ULPOWER AERO ENGINES N.V.

Service Bulletin No. 2019-01

UPDATE ON SERVICE BULLETIN 2016-02

SUBJECT: Bolts/washers securing the valve cover/rocker cover

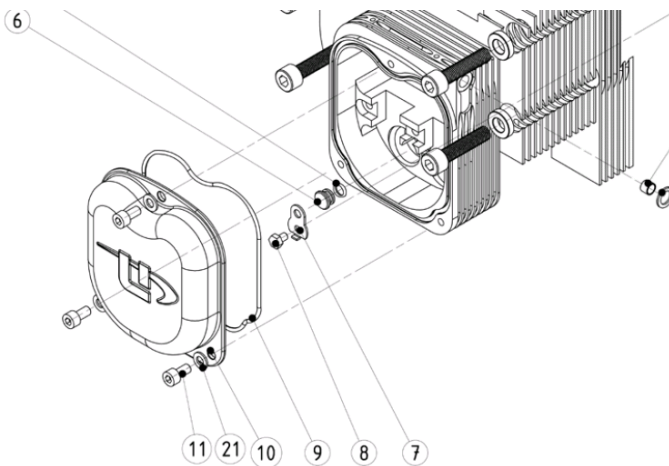
In service bulletin 2016-02, in response to isolated field reports of valve cover bolts loosening, we asked you to check these bolts (item 11) on a regular basis and to ensure that they are torqued to 6Nm.

Since September 2016, M5 Nordlock washers (item 21 – F2110050) have been installed between the valve covers and the valve cover bolts on all new and overhauled engines leaving factory. Since the introduction of the Nordlock washer in this location, there have been no field notifications in relation to these bolts loosening. Therefore, we now recommend the installation of M5 Nordlock washers as a secure and practical method of ensuring bolts in this location.

The specific characteristics of Nordlock washers will prevent bolts from in-service loosening through vibration, if installed the correct way and to the correct torque, removing the need for additional inspection of these bolts.

Insert NLW (item 21) between the valve cover (item 10) and the bolt (item 11).

Always use a torque wrench to tighten the bolt to the correct torque value as specified in the illustrated parts catalogue. (6 Nm in this case). We advise taking all three bolts to contact before torquing them.

How to (re) use Nordlock washers?

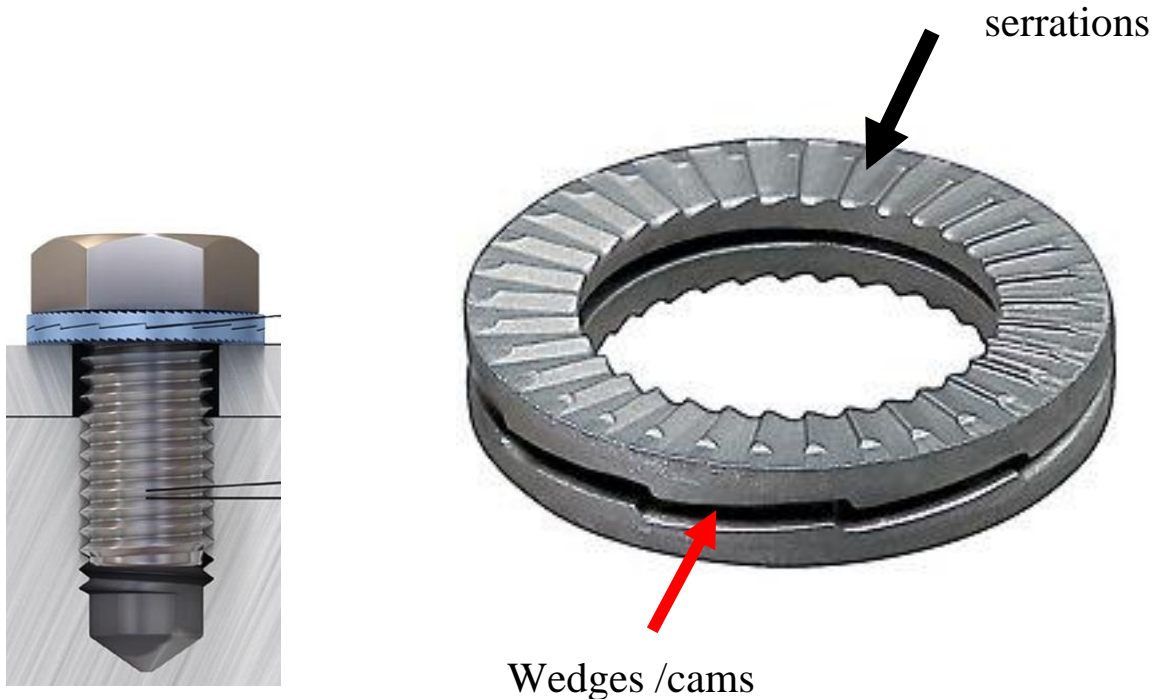
A Nordlock washer (NLW) is composed of two halves, which must be installed together, in the correct orientation. Each washer has serrations on the outside and wedges/cams on the inside. When using the new NLW you will notice that they are held together with a small amount of flexible glue .

Note: After first use, the pre-assembling glue is no longer effective, and the two halves may come apart. We advise you to keep the washers in correctly orientated pairs after removing them.

Before reinstallation you must confirm that the cams and serrations on the washer are not worn or damaged.

Only re-use NLW washers which are in good condition.

Always ensure that the NLW is assembled with the washer cam face to cam face, as shown above.
